# MARCO POLO - 101 W 33RD STREET

Date	Description
05.19.2022	Progress Set

2 RCP - 1ST FLOOR  
1" = 10'-0"

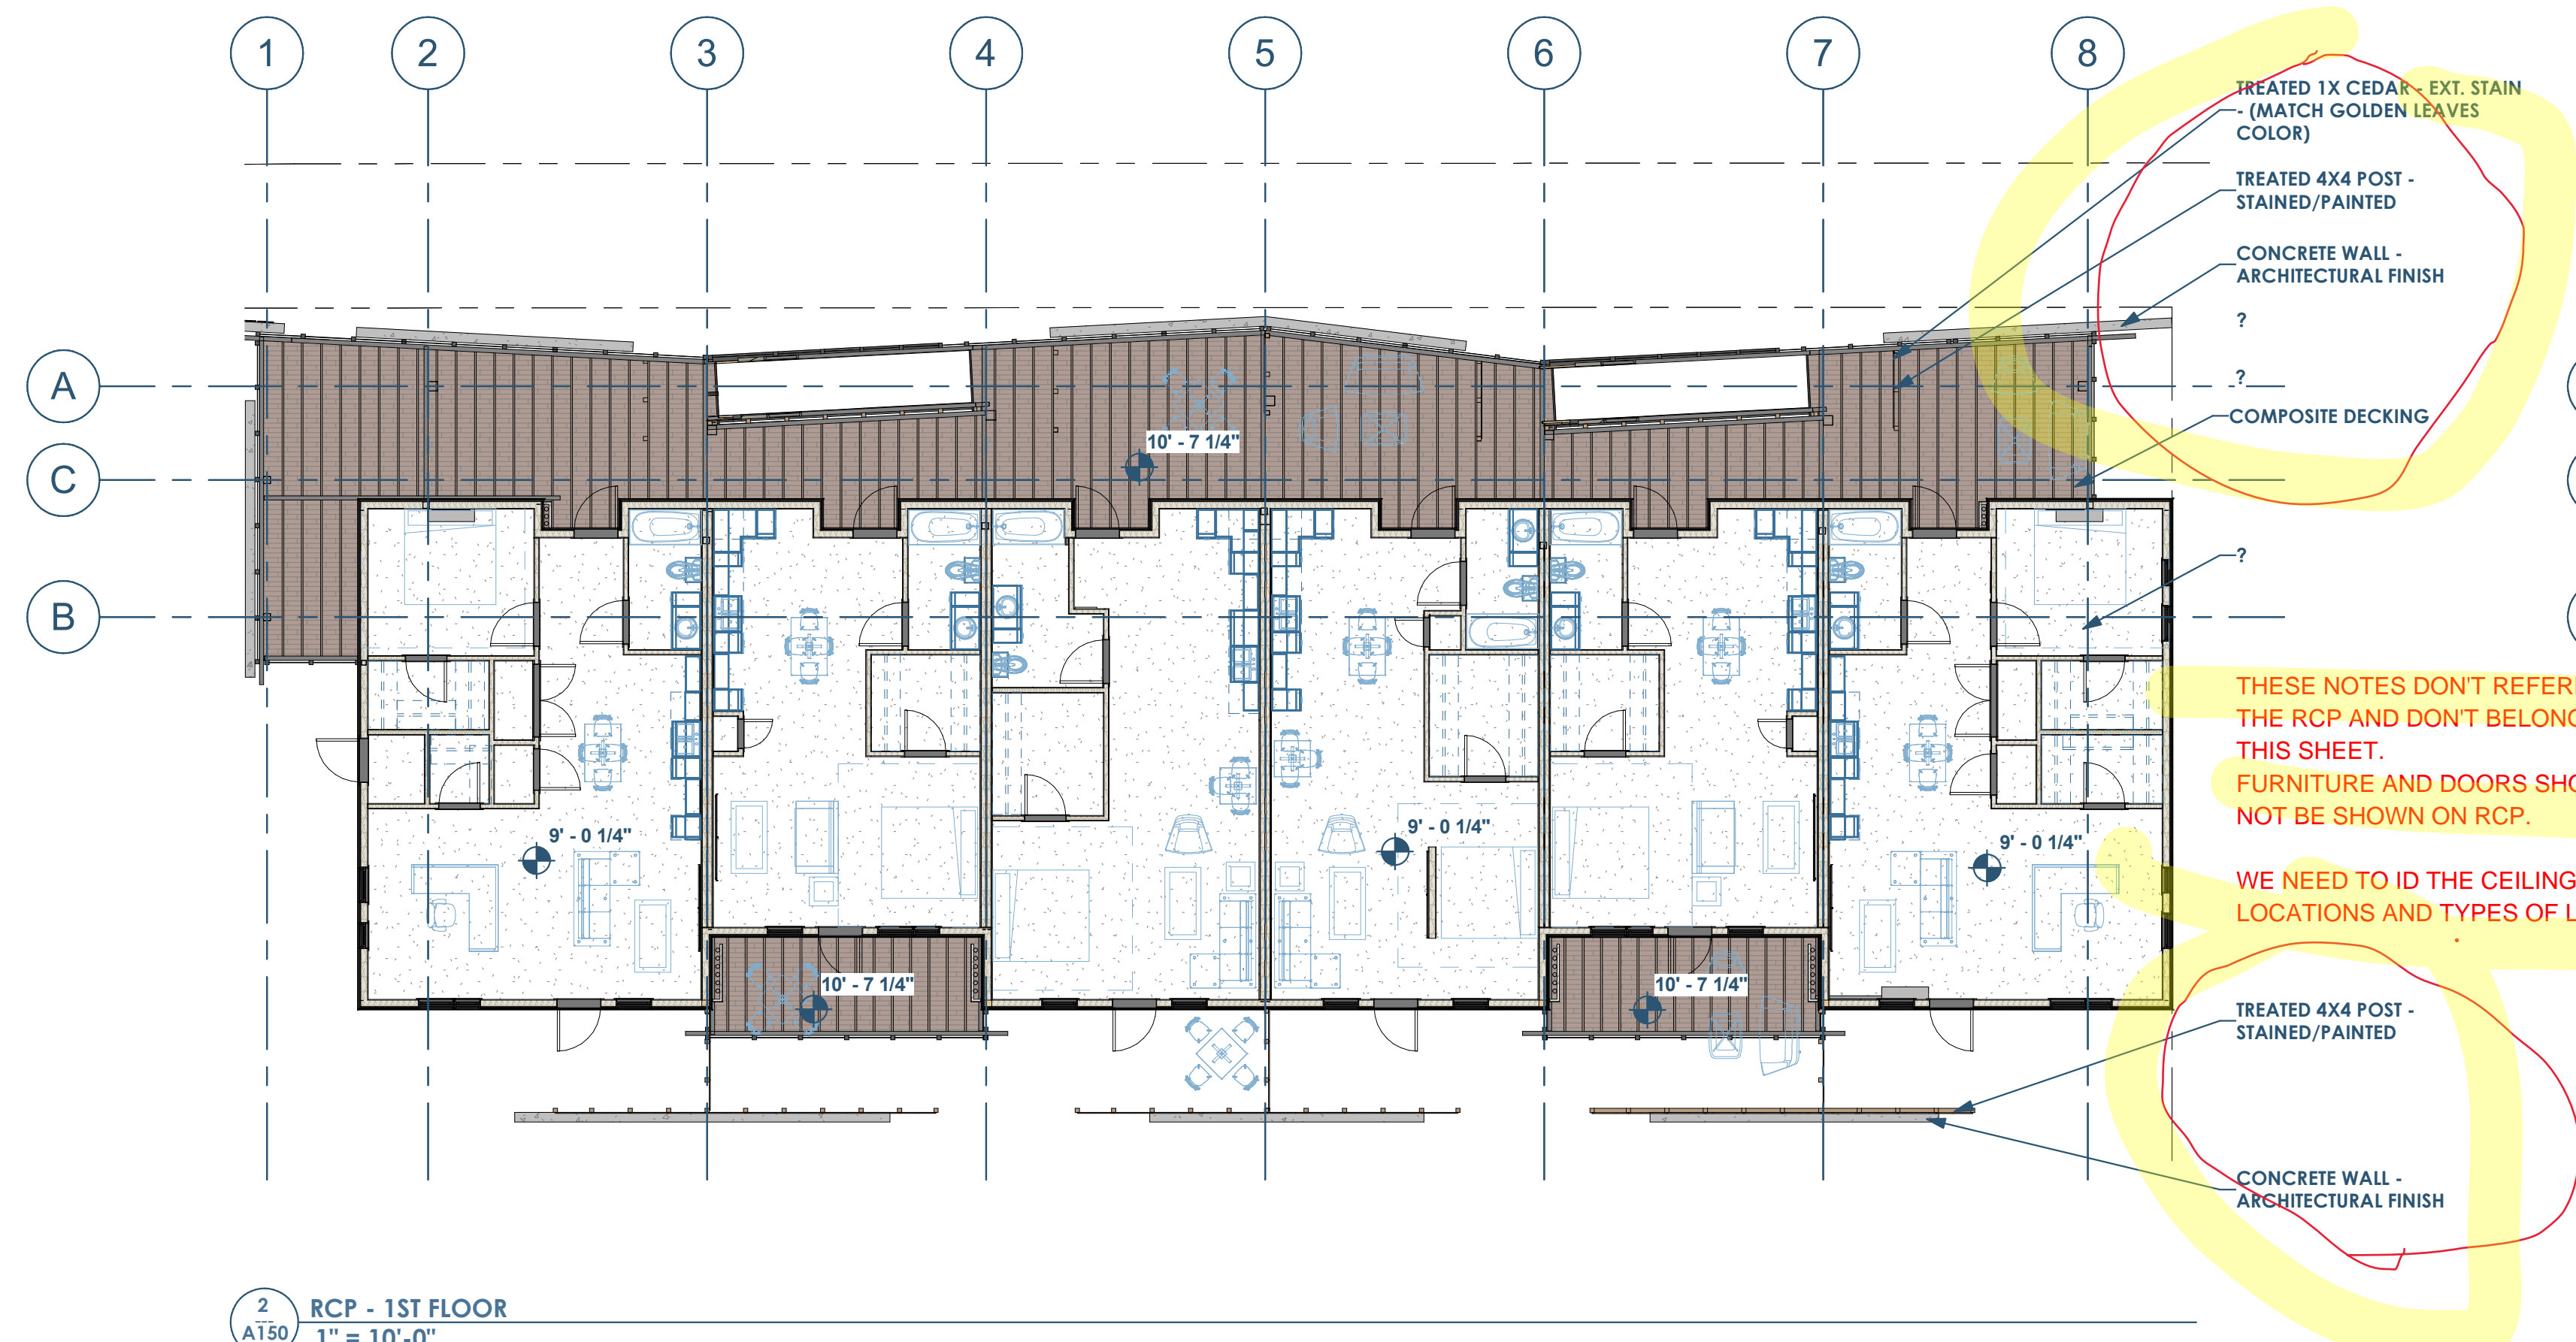
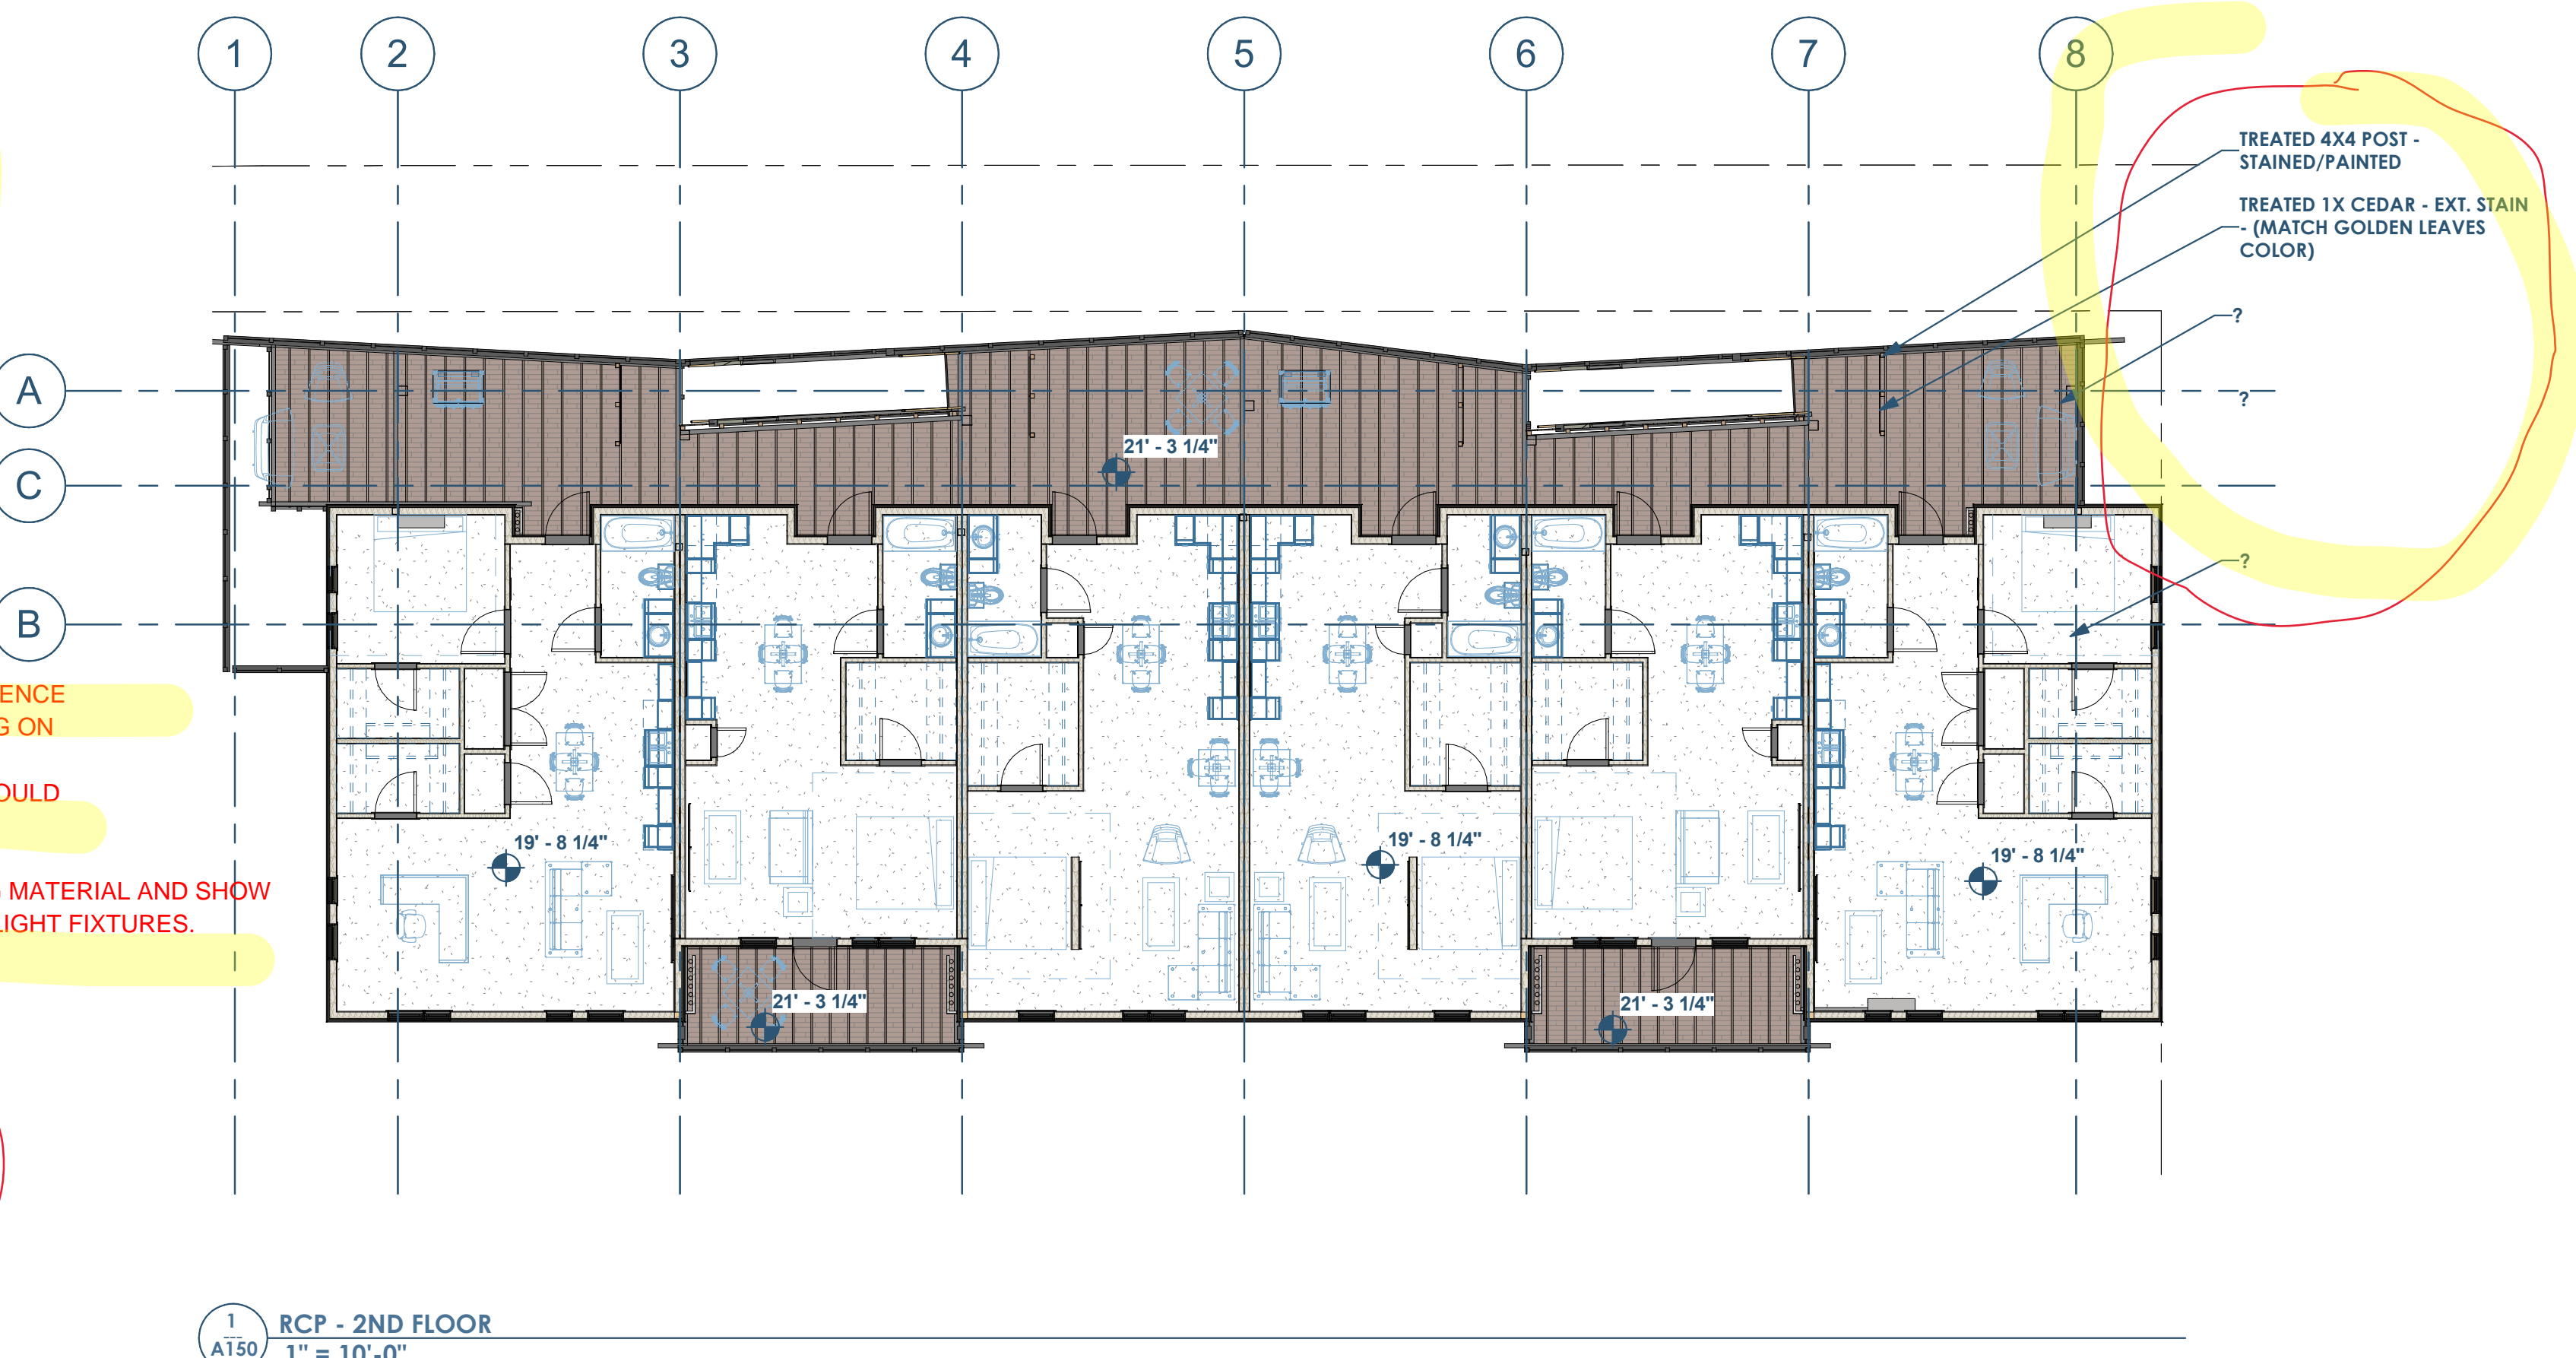
THESE NOTES DON'T REFERENCE THE RCP AND DON'T BELONG ON THIS SHEET.  
FURNITURE AND DOORS SHOULD NOT BE SHOWN ON RCP.

WE NEED TO ID THE CEILING MATERIAL AND SHOW LOCATIONS AND TYPES OF LIGHT FIXTURES.
